Rezoning Transportation Analysis

Petition Number: 2020-080

General Location Identifier: Tax ID 12110110

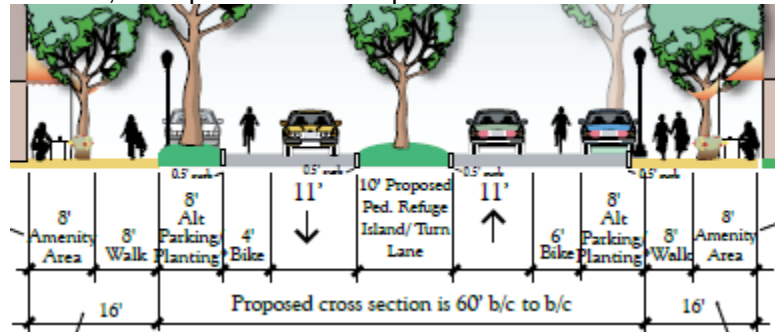
~~Traffic Study~~ A Traffic Impact Study is necessary for the complete review of this petition due to the site's generation of more than 2500 daily trips.

~~Staff will receive the petition and begin work on it, but the public hearing will not be scheduled until the TIS is received. This will allow for the minimum time necessary for CDOT to review and approve the study and reach agreement with the petitioner on the required transportation commitments, and have them included on the last site plan submitted no fewer than 4 weeks prior to the public hearing. Therefore, additional traffic mitigation comments may be forthcoming once the TIS is approved by CDOT and NCDOT.~~
